I-70 West Vail Pass Auxiliary Lanes
Eagle County, Colorado
Value Engineering Study Report - Final

R | 0
May 20, 2021

Project: NHPP 0702-404 / FBR 0702-403
Subaccount: 23982 / 23929

Idea 34

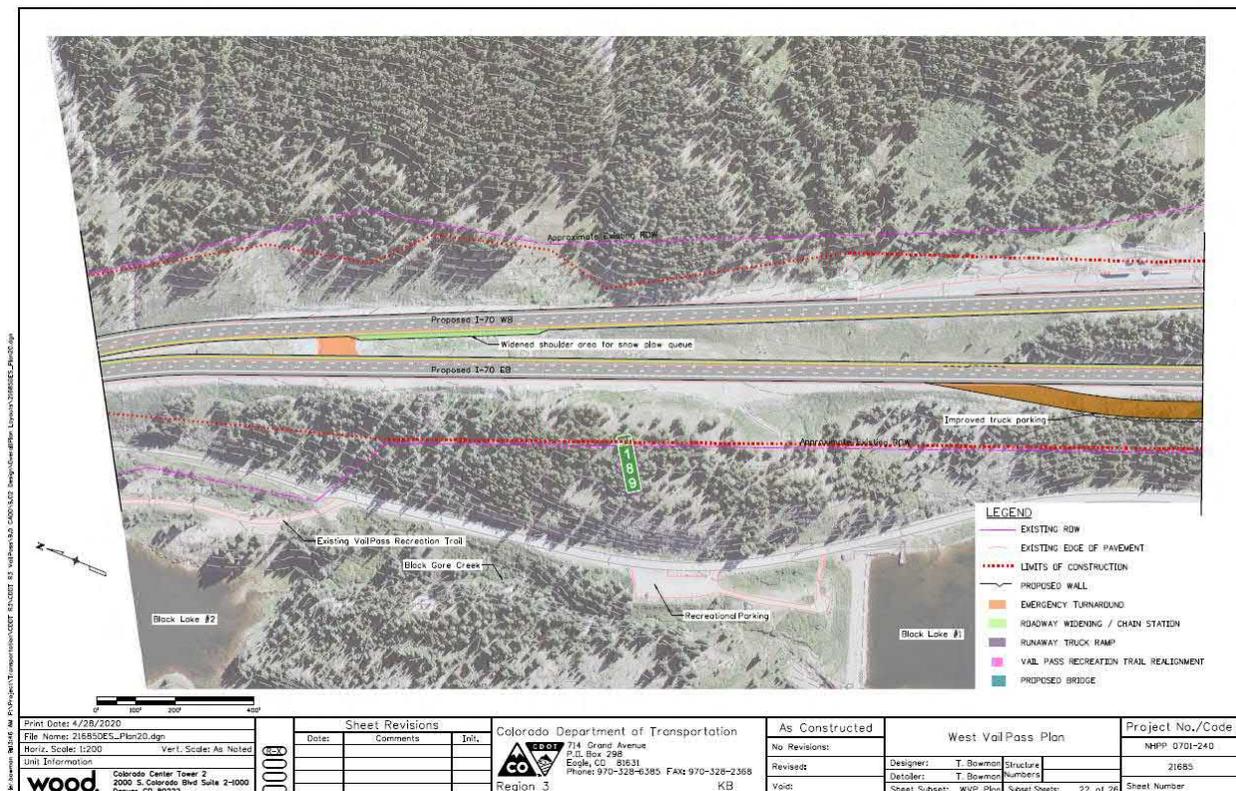
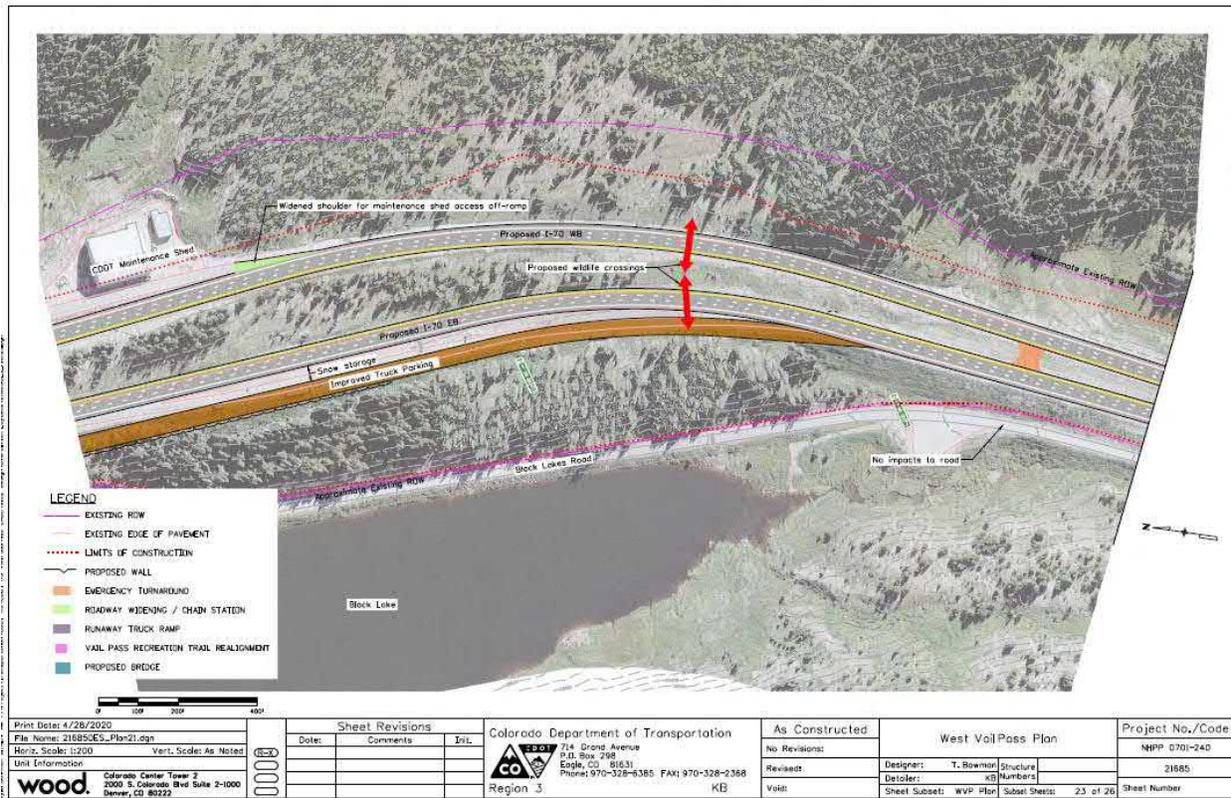
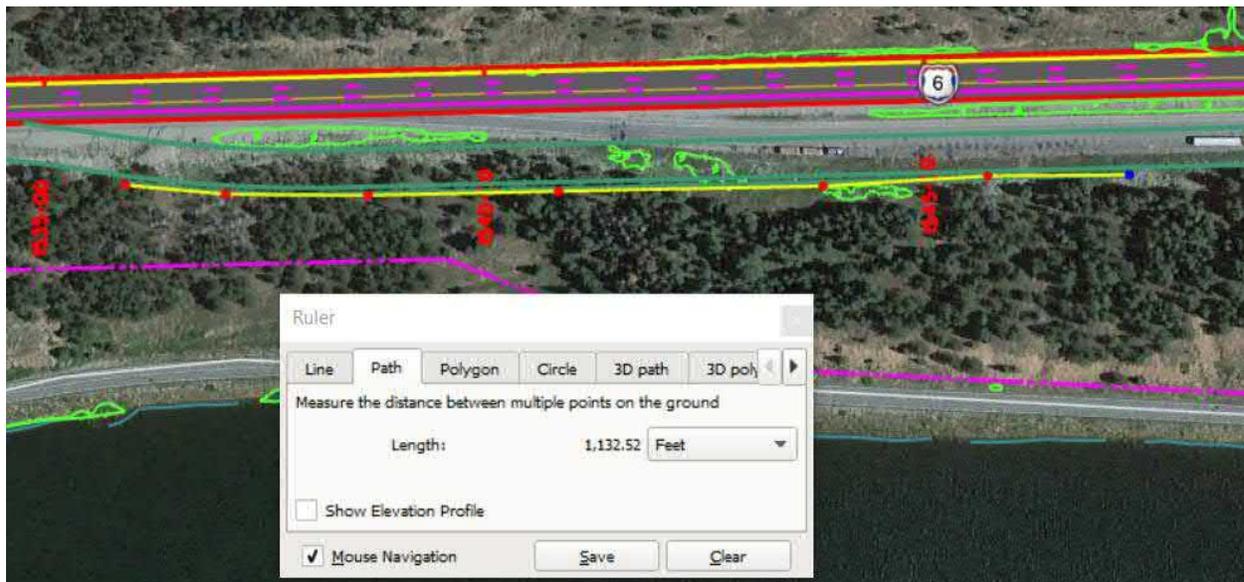
The following two drawings are from the I-70 Auxiliary Lanes report – Appendix C:

Using the provided Google Earth KMZ file, it appears the wall draw is approximately 1100 feet long.

Based on the contours in the project roll plots, the wall could be as high as 20-25 feet to catch the slope heading towards Black Lake Number 1. The construction of the wall and presence of the additional truck parking would have a negative visual impact for the trail users along the Ten-Mile Canyon National Recreation Trail.

Figure 1 – Bridge Plan

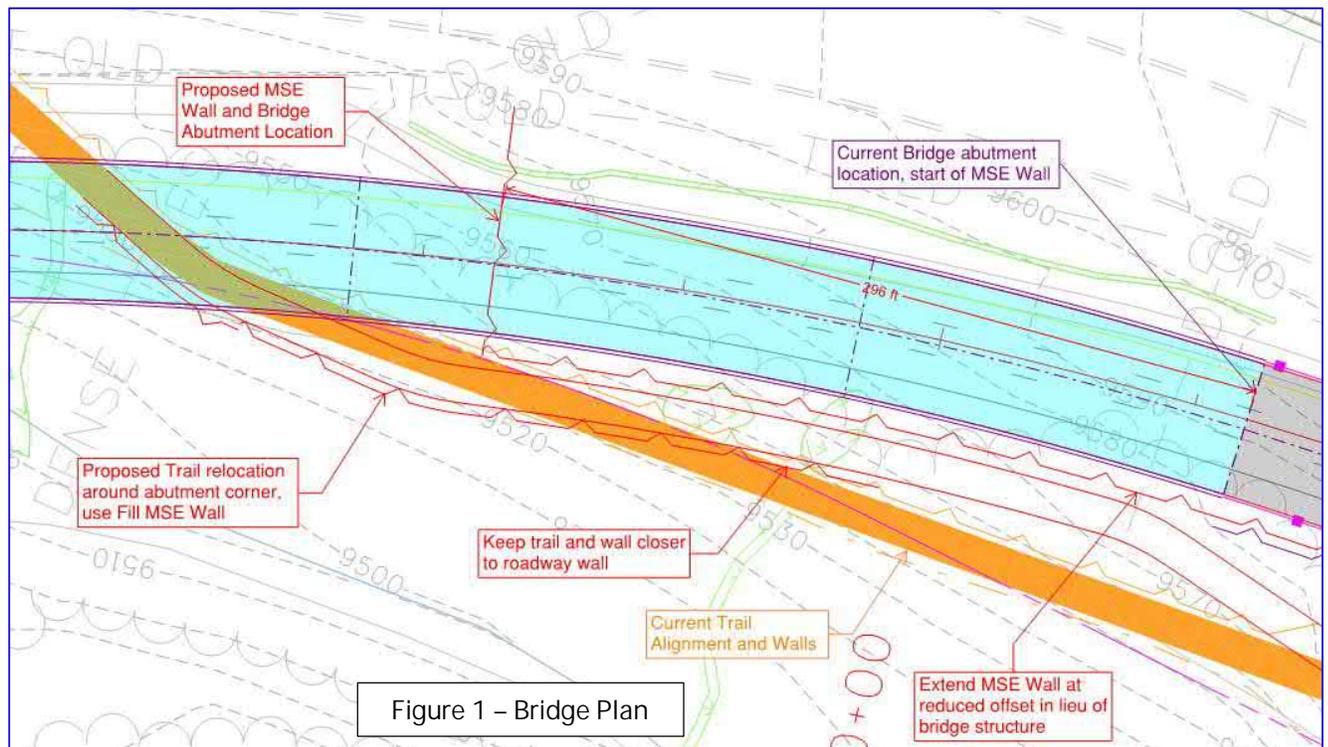
The proposal is to eliminate the south span and reduce the next span of the bridge (overall length reduction of approximately 300') and replace with MSE Wall on the right side and fill on the left side. Roadway pavement, base, and guardrail would be extended accordingly, see Figures 1 and 2.

In addition, the Trail alignment would be modified to push out around the shifted abutment location, but then kept parallel to the new MSE wall to reduce the overall amount of wall needed for the Trail.

Figure 3 - Cross Sections

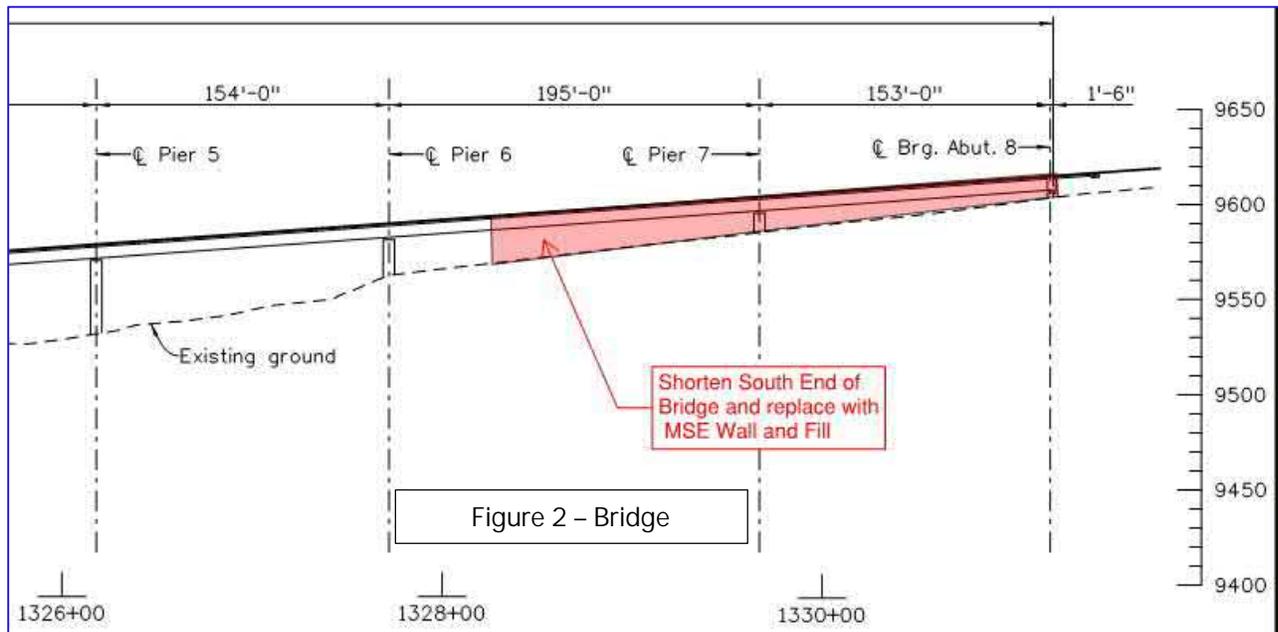
See Figure 3 for Cross Sections of this area.

Idea 40

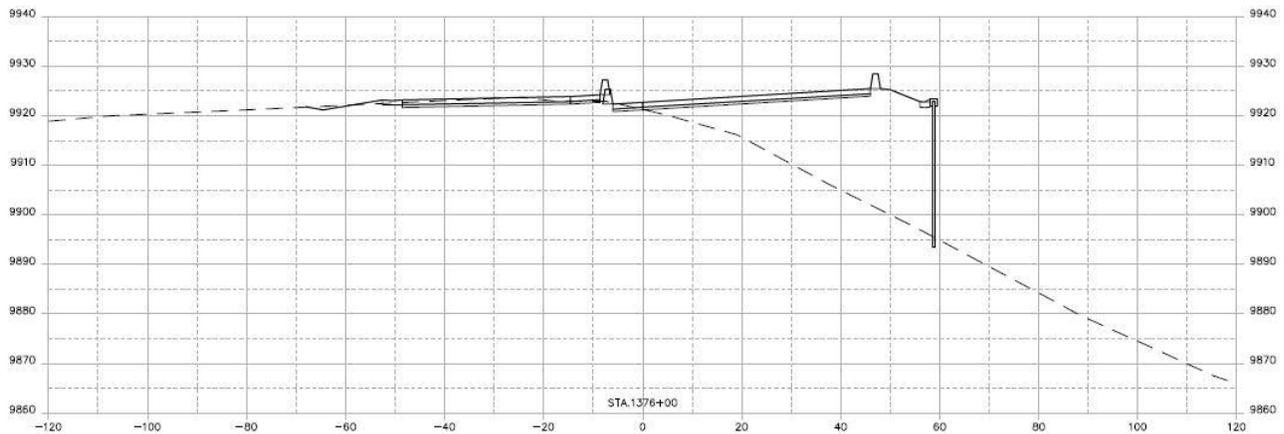
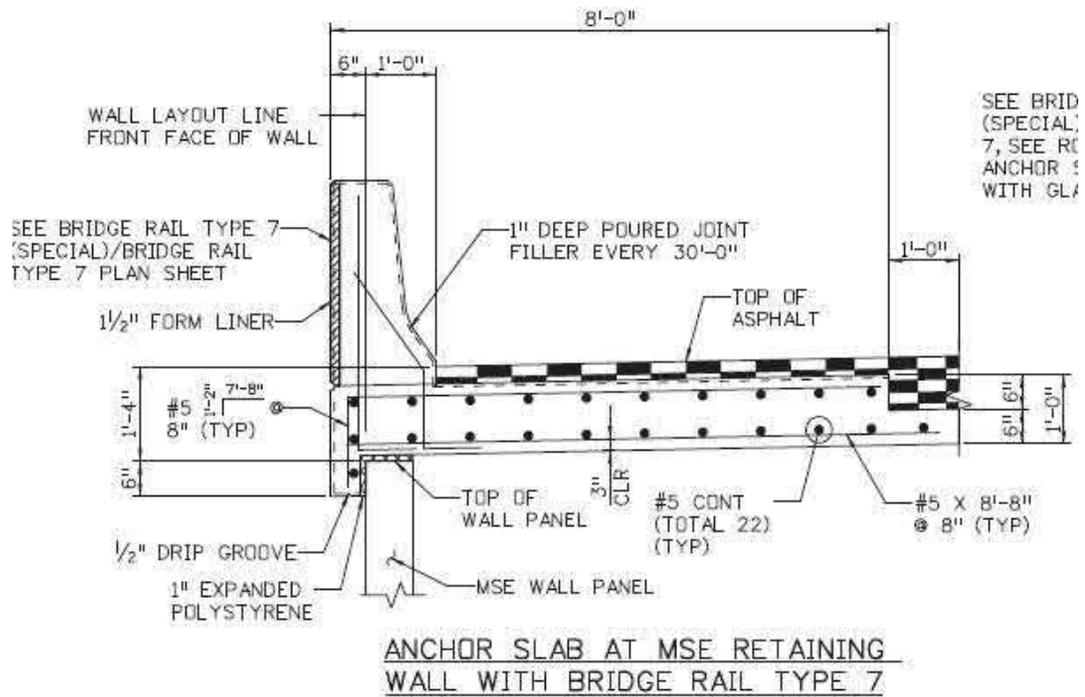
This design suggestion is to consider using an anchor slab on top of the fill walls with integral barrier in select locations as opposed to the current offset proposed in the current design. Quantification of the cost/schedule impacts are unknown without further design/refinement but could be advanced by the design/contractor team if this proposal is considered further.

The current design approach for the fill walls use as offset from the back of barrier/guardrail to provide the stability for the roadside barrier with the bench and slope to the top of wall. This proposal would use the anchor slab to provide the stability required and allow the wall to be shifted back towards the roadway towards the base of the barrier.

Idea 39

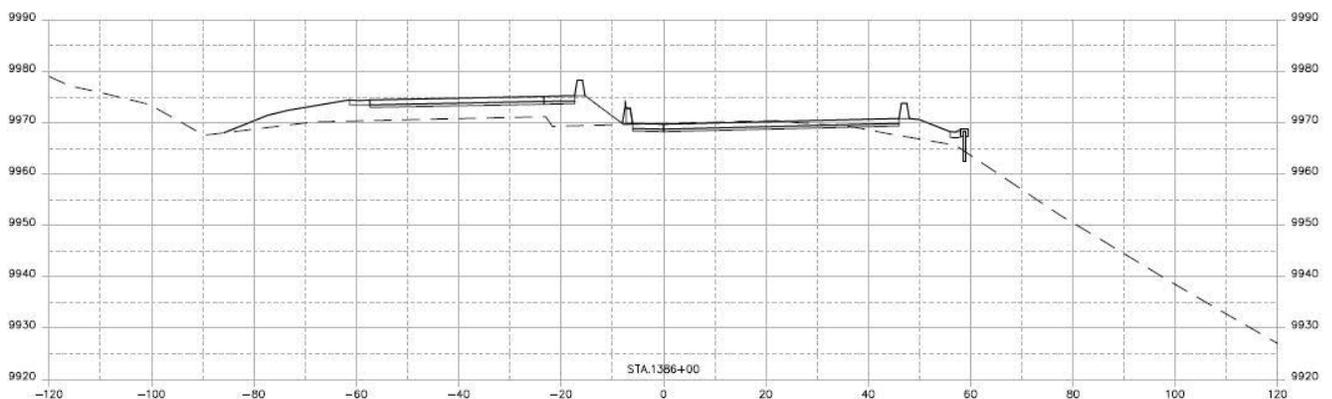
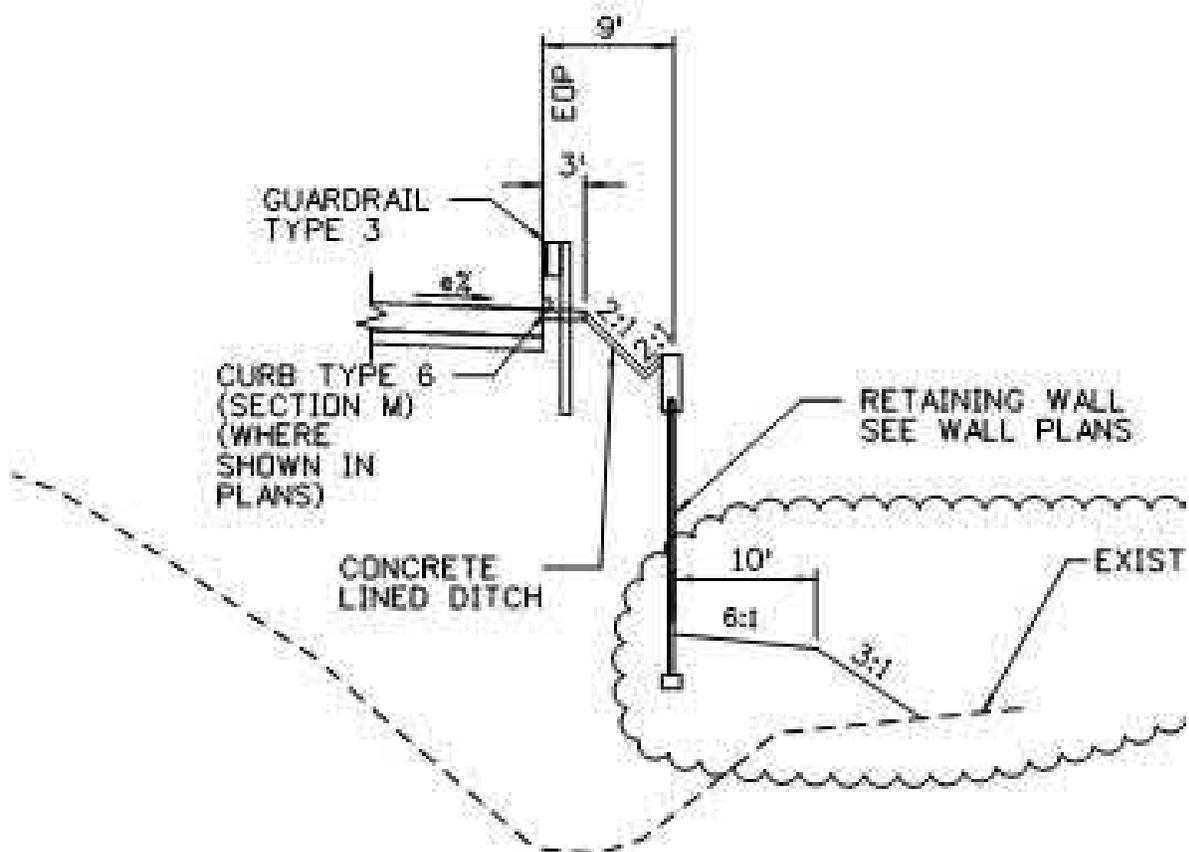
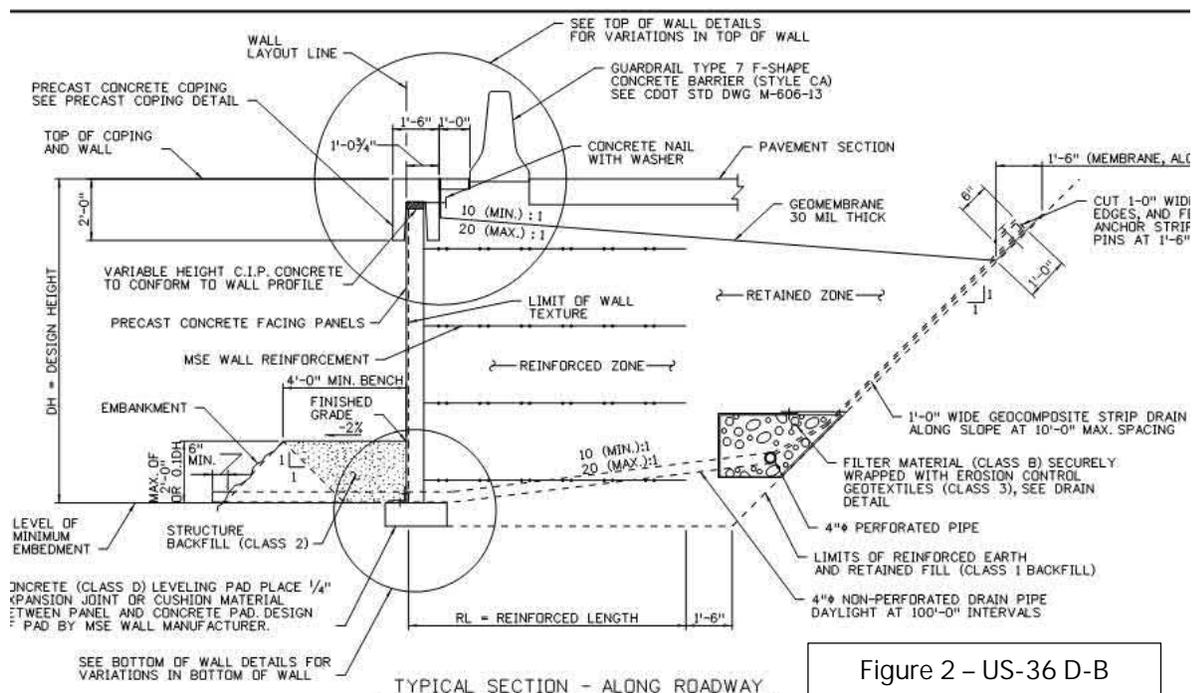
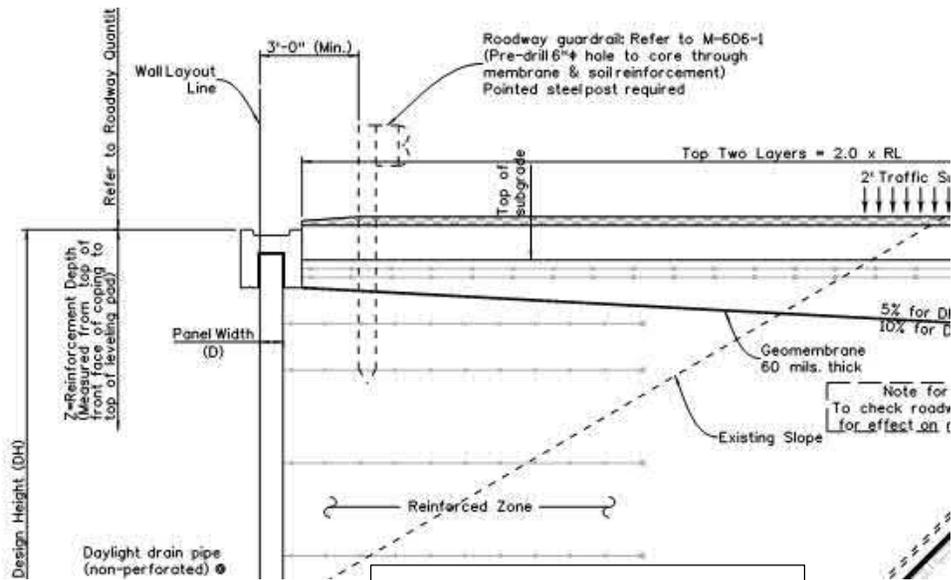
This design suggestion is to consider using an anchor slab in lieu of retaining wall in select locations that have a grade difference of less than approximately three feet. Instead of a retaining wall in these locations, this suggestion is to use an anchor slab system that is able to retain the material without the need for an additional retaining wall.

The estimate is based on changing from a 13' offset to a 9' offset and keeping Type 9 barrier and assumes a 2:1 slope at the toe for an average height reduction of 2', and an average 20' wall height for earthwork calculations.

The proposal will be considered where feasible in the INFRA Grant scope design. The proposal is accepted with modifications. Sediment collection needs to be considered.

Idea 8

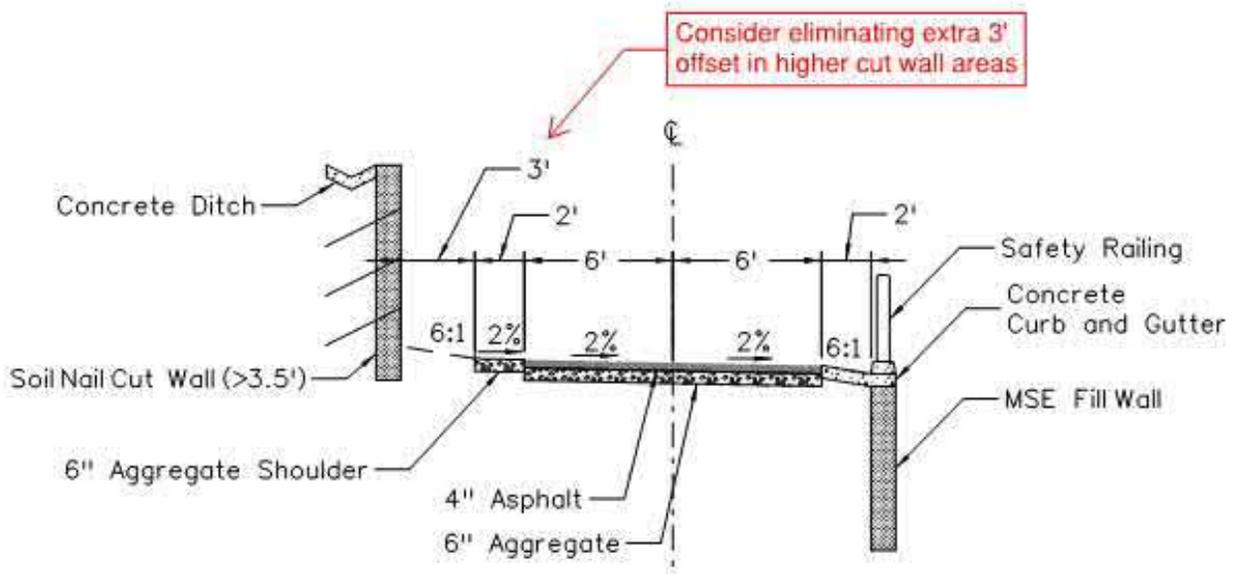
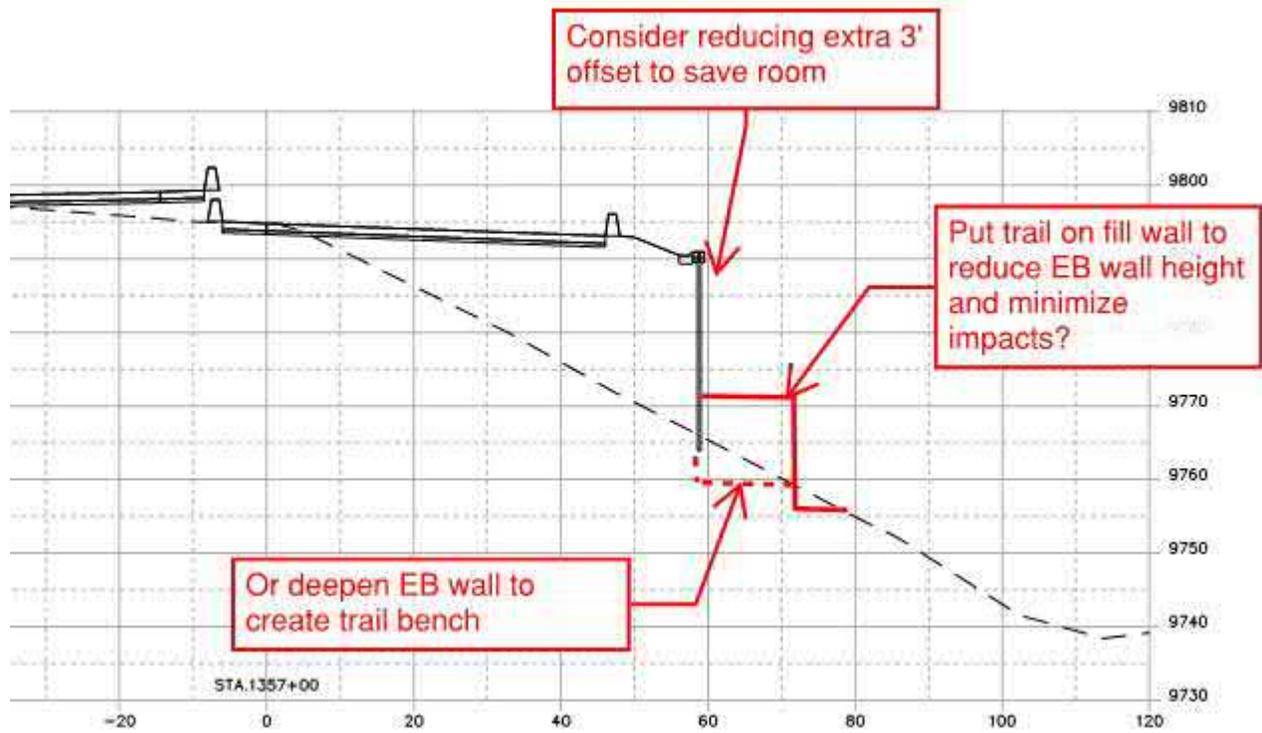
The proposal is to eliminate or reduce the extra 3' offset to face of walls. The trail paved section is 12' wide, with 2' ABC shoulders on each side, which already mitigates the closed-in feeling when adjacent to walls.

- 1328+00 – 1331+00: Trail is against extended bridge abutment MSE wall and has a fill wall on the outside in this area. Reducing offset would reduce outside wall height.
- 1356+00 – 1362+00: Trail is between roadway MSE wall on the left and adjacent creek and wetlands on the right. Reducing offset would reduce impacts to wetlands and potentially creek
